SUBJECT: QUAD CITIES - ISSUANCE OF AMENDMENTS - REVISED PRESSURE-TEMPERATURE LIMITS (TAC NOS. MA7138 AND MA7139)

The U.S. Nuclear Regulatory Commission (Commission) has issued the enclosed Amendment No. 195 to Facility Operating License No. DPR-29 and Amendment No. 191 to Facility Operating License No. DPR-30 for the Quad Cities Nuclear Power Station, Units 1 and 2, respectively. The amendments are in response to your application dated November 12, 1999, as supplemented by letter dated January 10, 2000.

The amendments change Technical Specification (TS) 3/4.6.K to revise the reactor pressure boundary pressure-temperature limits, change TS 3/4.12.C to delete a special test exception which allows performance of the hydrostatic test above 212 degrees Fahrenheit while in Mode 4, and change TS 3/4.6.P to clarify the operability requirements for the residual heat removal system during the hydrostatic test.

FIGURE 3.6.K-1

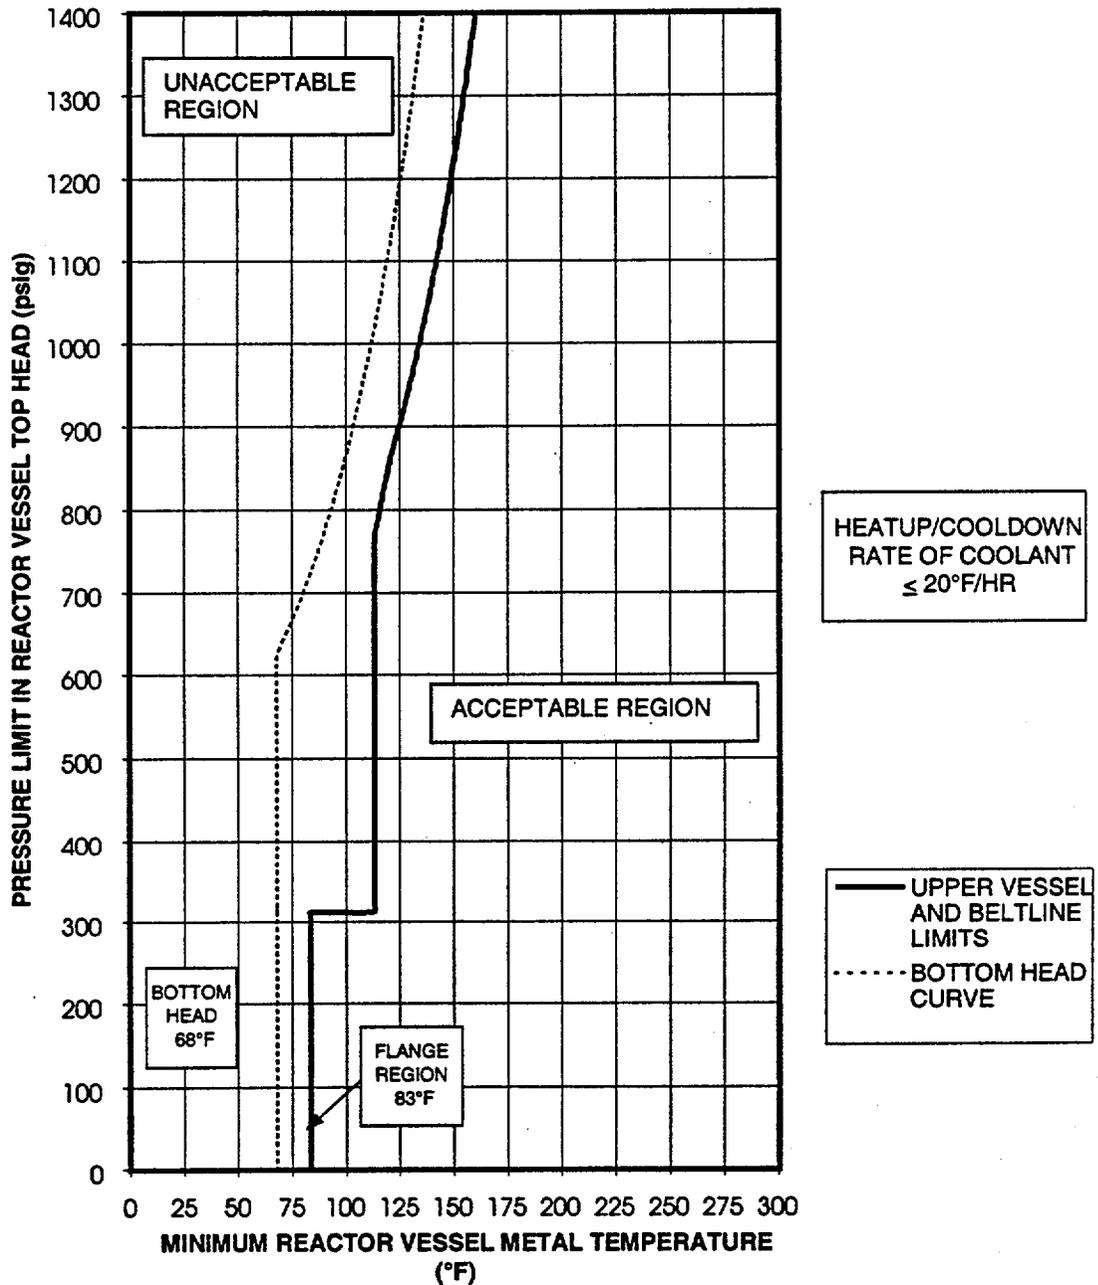
1. Pressure Testing:
  - a. The reactor vessel metal temperature and pressure shall be maintained within the Acceptable Regions as shown on Figure 3.6.K-1 with the rate of change of the primary system coolant temperature  $\leq 20^{\circ}\text{F}$  per hour, or
  - b. The rate of change of the primary system coolant temperature shall be  $\leq 100^{\circ}\text{F}$  per hour when reactor vessel metal temperature and pressure is maintained within the Acceptable Regions as shown on Figure 3.6.K-2.
2. Non-Nuclear Heatup and Cooldown and low power PHYSICS TESTS:
  - a. The reactor vessel metal temperature and pressure shall be maintained within the Acceptable Regions as shown on Figure 3.6.K-2, and
  - b. The rate of change of the primary system coolant temperature shall be  $\leq 100^{\circ}\text{F}$  per hour.

As indicated in Figure 3.3.6.K-1 for pressure testing, the minimum metal temperature of the reactor vessel shell is 83°F for reactor pressures less than 312 psig. This 83°F minimum boltup temperature is based on a  $RT_{NDT}$  of 23°F for the electroslag weld immediately below the vessel flange and a 60°F conservatism required by the original ASME Code of construction. The bottom head region limit is established as 68°F, based on moderator temperature assumptions for shutdown margin analyses. At reactor pressures greater than 312 psig, the minimum vessel metal temperature is established as 113°F. The 113°F minimum temperature is based on a closure flange region  $RT_{NDT}$  of 23°F and a 90°F conservatism required by 10CFR Part 50 Appendix G. Beltline curves as a function of vessel exposure for 32 effective full power years (EFPY) are presented.

Figure 3.6.K-1 is governing for applicable pressure testing with a maximum heatup/cooldown rate of 20°F/hour.

FIGURE 3.6.K-2  
PRESSURE - TEMPERATURE LIMITS FOR NON-NUCLEAR  
HEATUP/COOLDOWN - VALID TO 32 EPFY

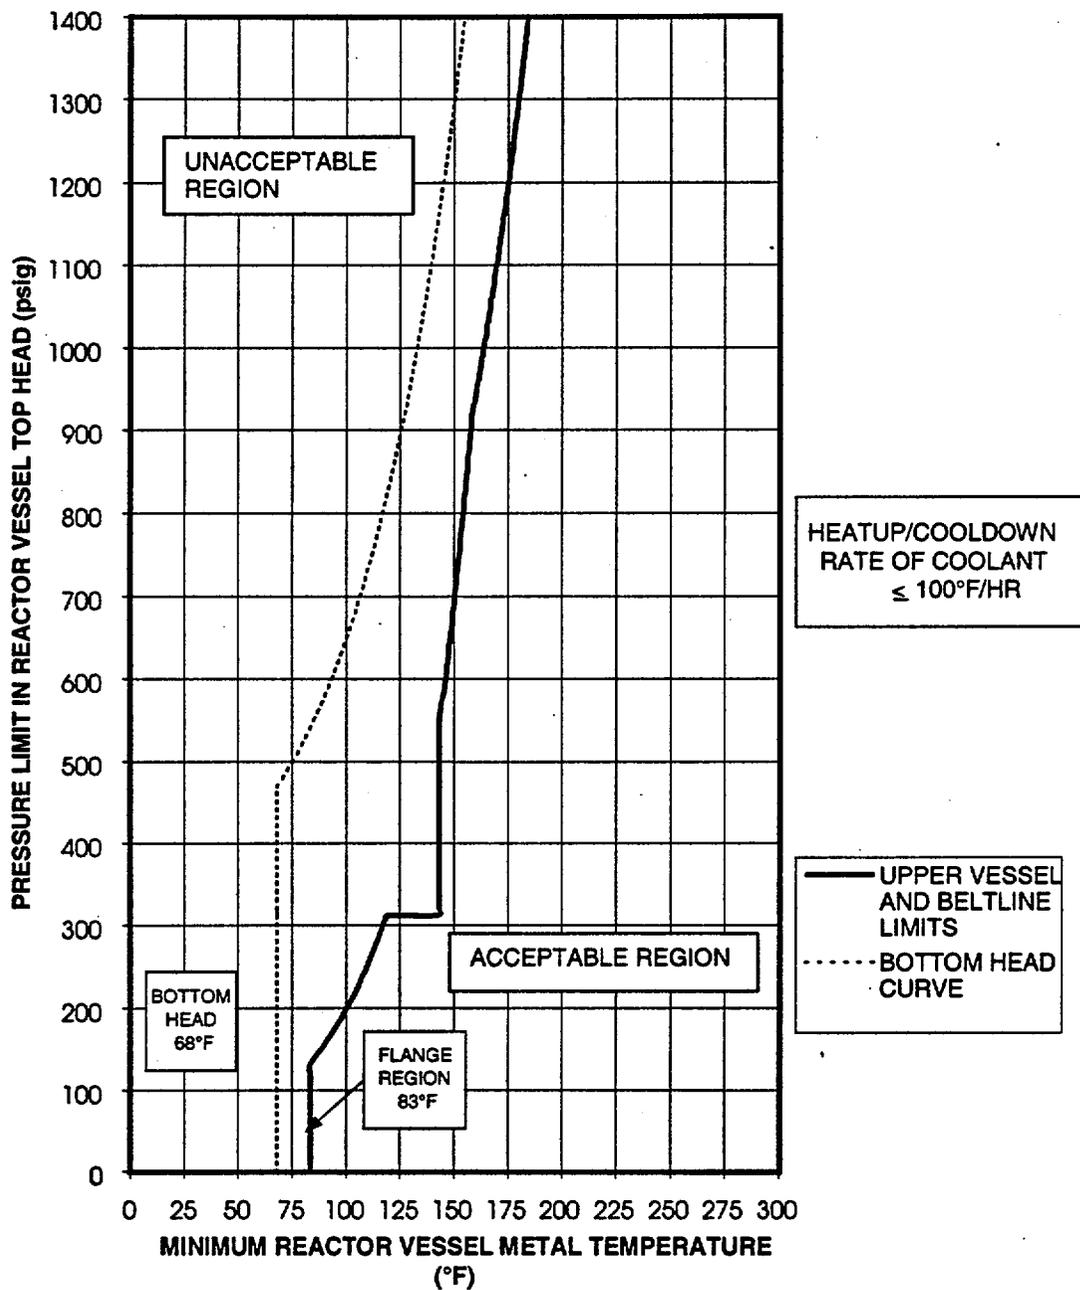
Figure 3.6.K-2 applies during heatups with non-nuclear heat (e.g., recirculation pump heat) and during cooldowns when the reactor is not critical (e.g., following a scram). The curve provides the minimum reactor vessel metal temperatures based on the most limiting vessel stress. The maximum heatup/cooldown rate of 100°F/hour is applicable.

FIGURE 3.6.K-3  
PRESSURE - TEMPERATURE LIMITS FOR CRITICAL  
CORE OPERATIONS - VALID TO 32 EFY

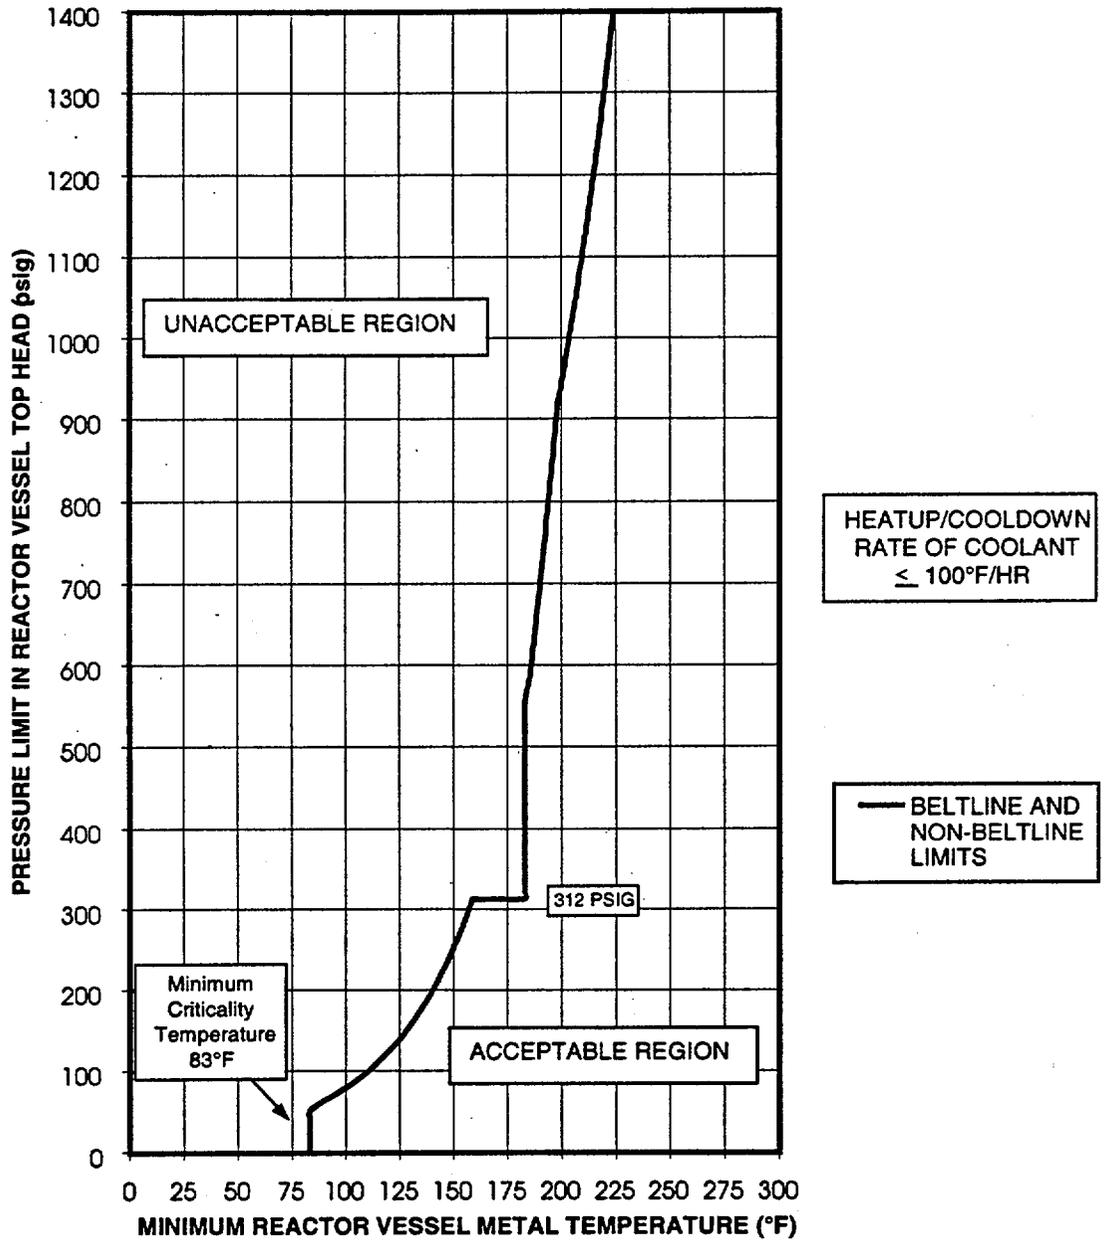
3. Nuclear Heatup and Cooldown:
  - a. The reactor vessel metal temperature and pressure shall be maintained within the Acceptable Region as shown on Figure 3.6.K-3, and
  - b. The rate of change of the primary system coolant temperature shall be  $\leq 100^{\circ}\text{F}$  per hour.
4. The reactor vessel flange and head flange temperature  $\geq 83^{\circ}\text{F}$  when reactor vessel head bolting studs are under tension.

The core critical operation curve shown in Figure 3.6.K-3, is generated in accordance with 10CFR Part 50 Appendix G which requires core critical pressure-temperature limits to be 40°F above any Pressure testing or non-nuclear heatup/cool-down limits.
